Corrections to GRE/2018/43 – UN R10.06

The text reproduced below was prepared by TF EMC with the aim:

- to clarify definition of OTS
- to update failure criteria for vehicle in charging mode in Annexes 6, 15 and 16
- to update figures for ESA immunity test in annex 9

Figure 1

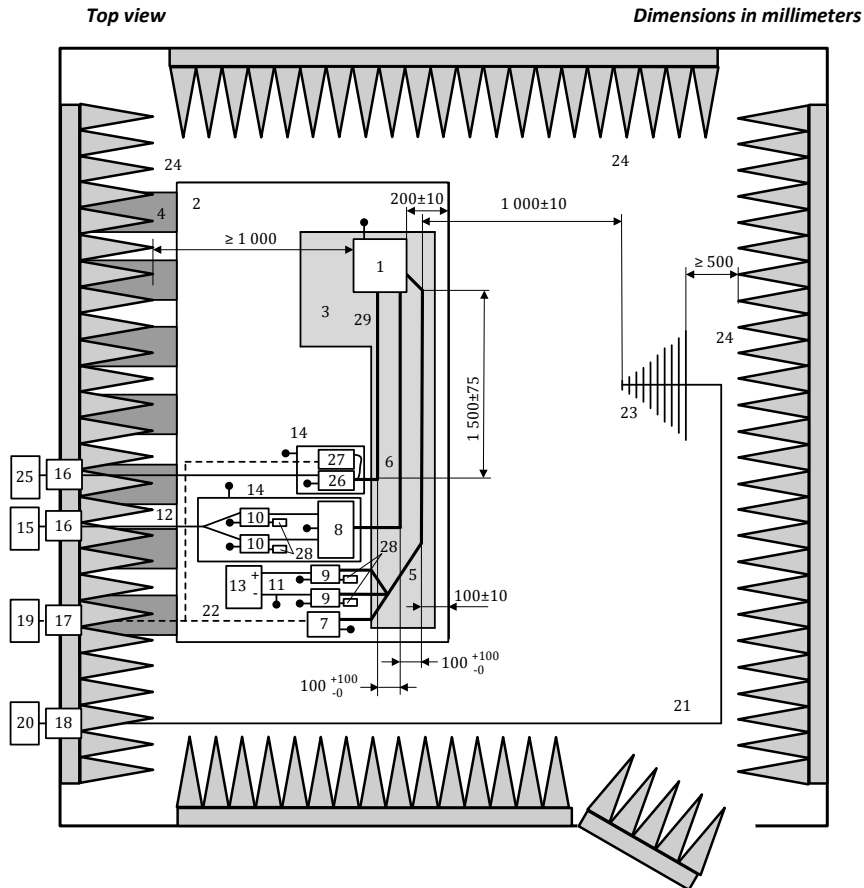
Annex 9, Appendix 3, delete and replace by:

Test configuration for ESA's involved in "REESS charging mode coupled to the power grid". The test shall be performed according to ISO 11452-2.
